# Staff Report PC23-056-ADP Chick-fil-A Development Plan

Meeting Date: January 9, 2024

## Docket PC23-056-ADP – Development Plan – Chick-fil-A

**SITE PLAN**  
SHEET NUMBER  
C-2.0

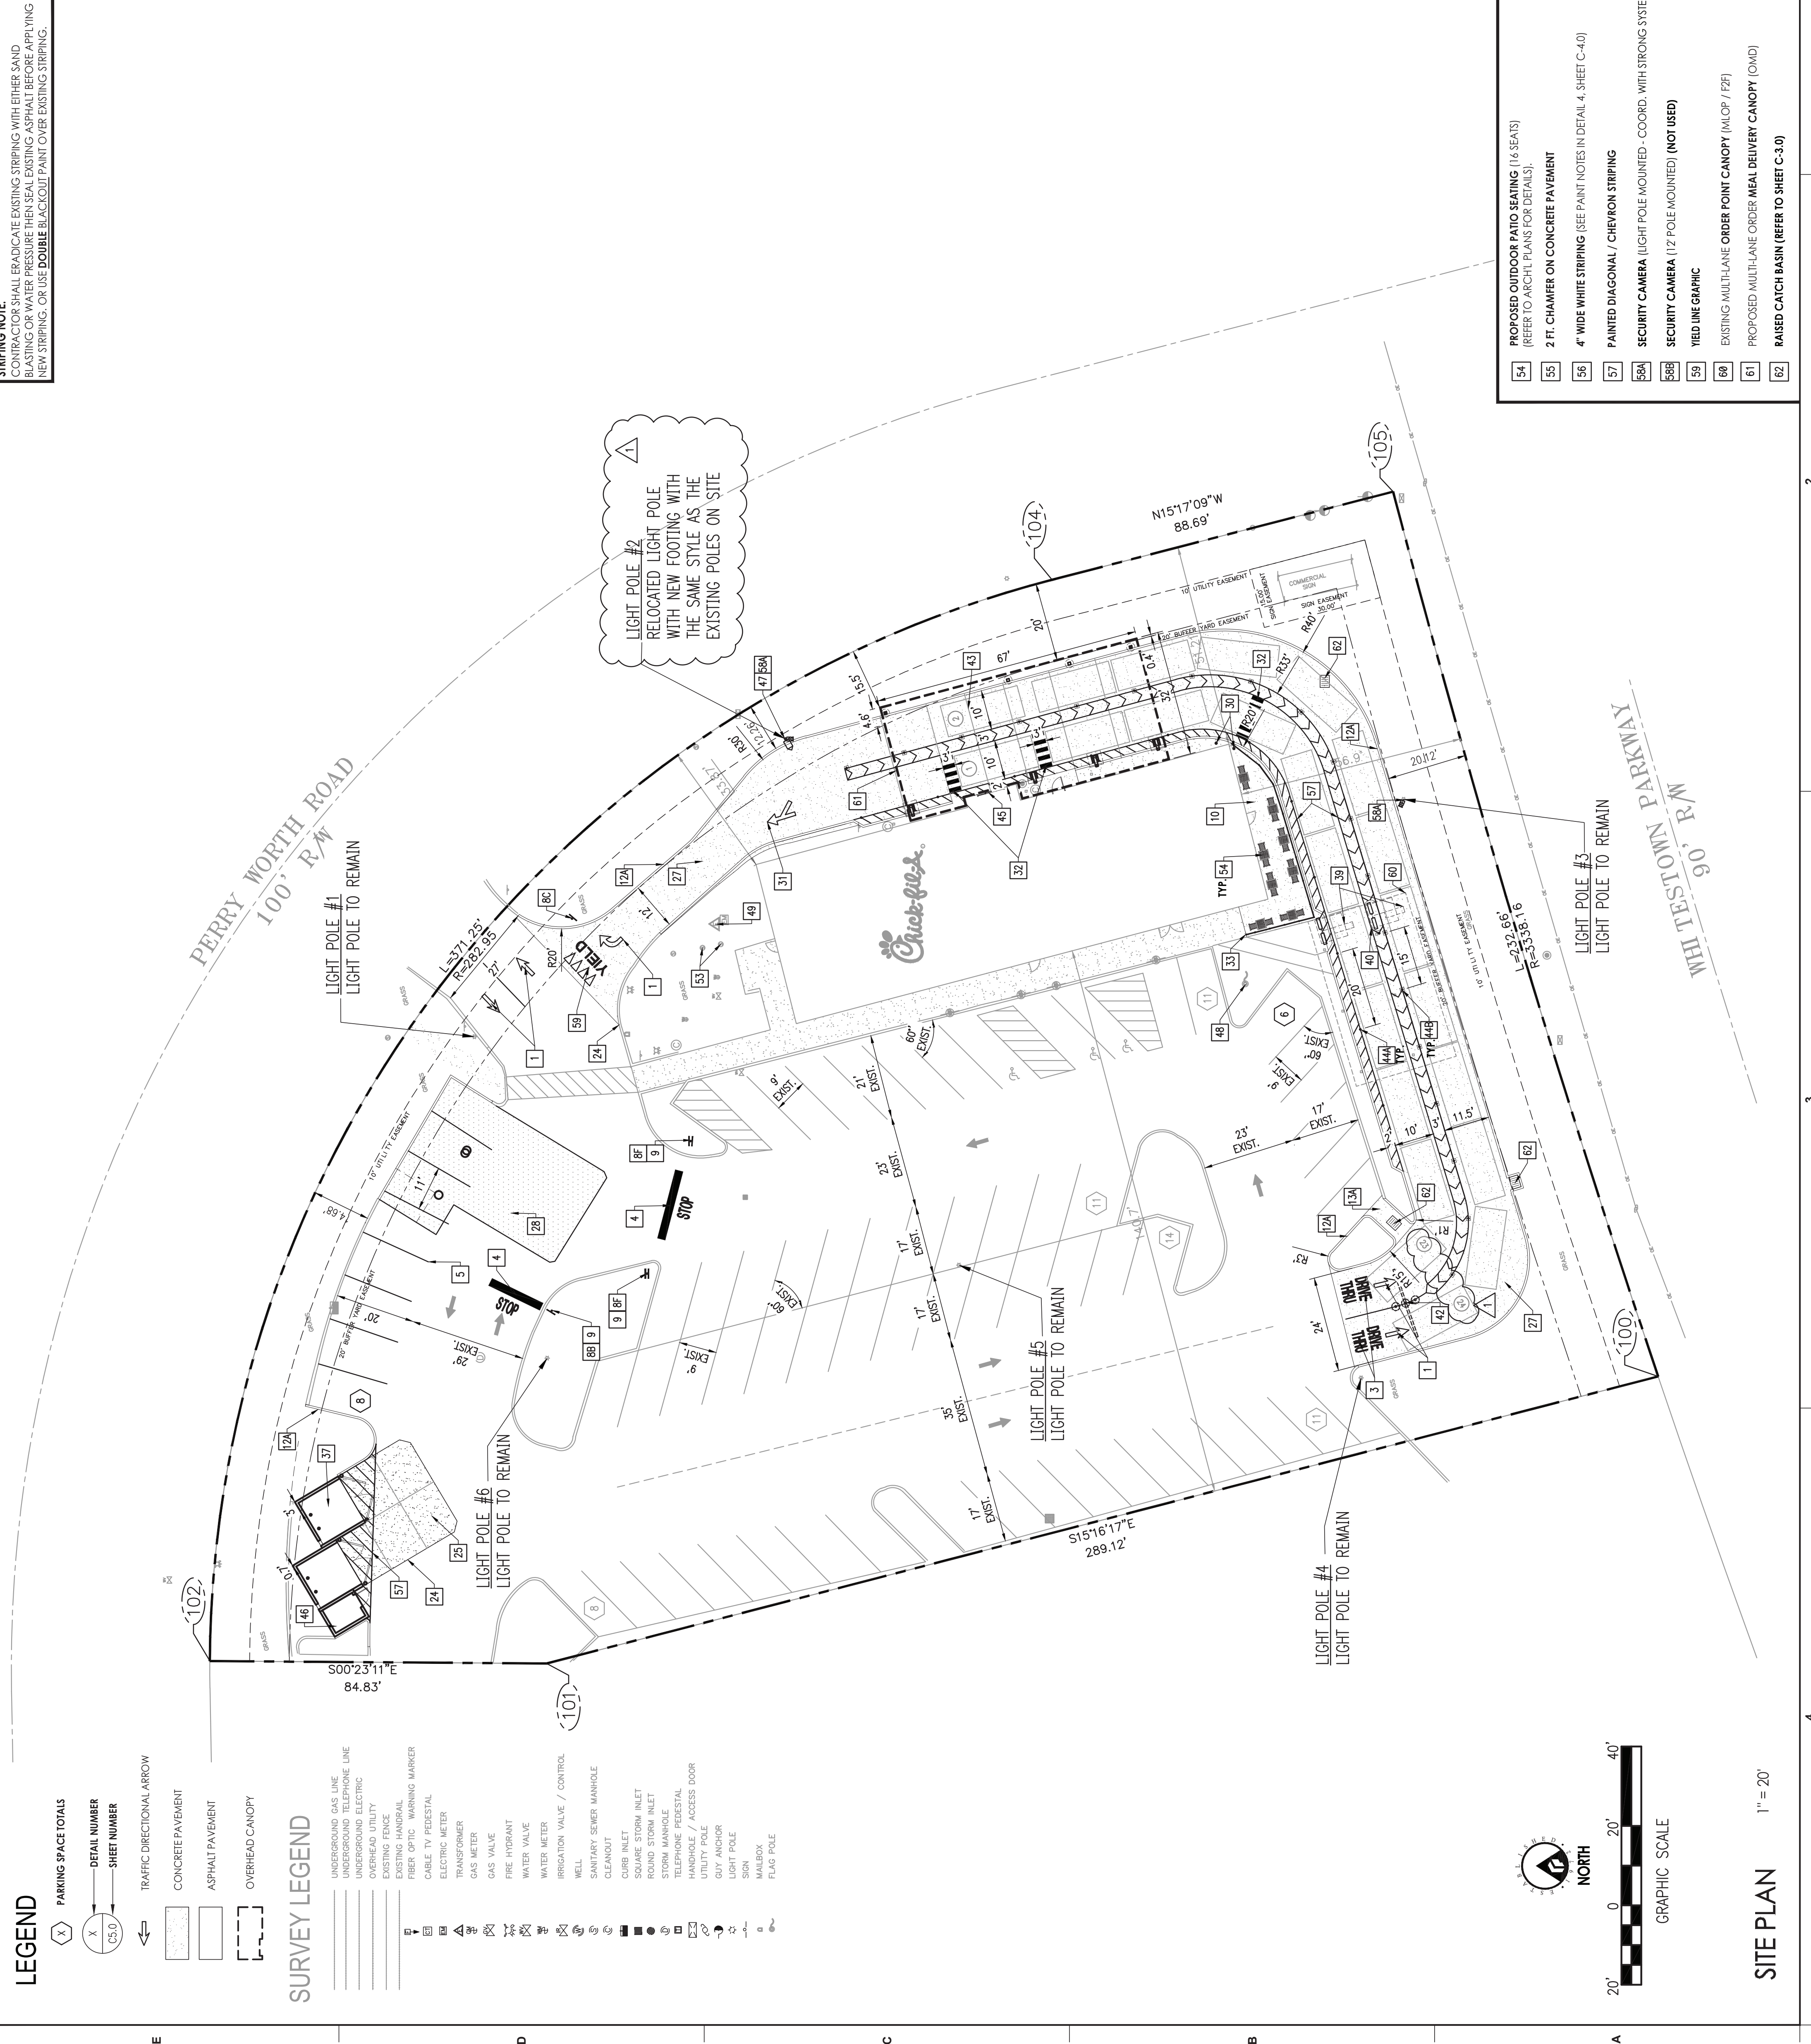
- Proposed delivery canopy on the east side of the site;
  - o Located 15.5' from Perry Worth Road where the requirement is 20'.
- Proposed expansion of the existing drive-thru lane circulation;
  - o There is no bypass lane provided.
- Relocating the dumpster enclosure;
- Architectural elevations that meet the requirements of the PUD;
- Photometric plan that meets the requirements of the PUD and UDO;
- Landscaping plan that meets the requirements of the PUD and UDO.

The applicant is proposing alternate plans from the Anson PUD. There are two requests, the first is to construct the canopy within the 20' required setback (Anson PUD Exhibit E). Due to the curve of Perry Worth Road the canopy is located partially within the setback, and is 15.5' from the property line.

The second request is to not have a bypass lane around the drive-thru. The applicant is proposing to expand the existing drive-thru to have two active drive-thru lanes and no bypass (Anson PUD Section 24.7 (g)(2)(v)).

There are multiple site constraints that make improvements to the site difficult. The site has multiple frontages which limits the buildable area. Due to the curve of Perry Worth Road, the proposed canopy will only impede the setback on the northern corner, while the southern part of it will comply with the required setback. The proposed canopy is not enclosed and will not impede visibility.

While no bypass lane is proposed, the proposed drive-thru expansion will increase the drivable area compared to what is existing today. The existing bypass lane is only partially existing today because it converges with the ordering line before expanding back out. Having two full lanes will prevent the bottleneck from occurring thereby improving the circulation. The increased circulation, as per this proposal, facilitates smoother traffic flow, making it easier for people to enter and exit the premises, thus enhancing overall safety and convenience.

Staff is providing a favorable recommendation for the two Chick-fil-A Changes in Development Standards for Docket PC23-056-ADP.
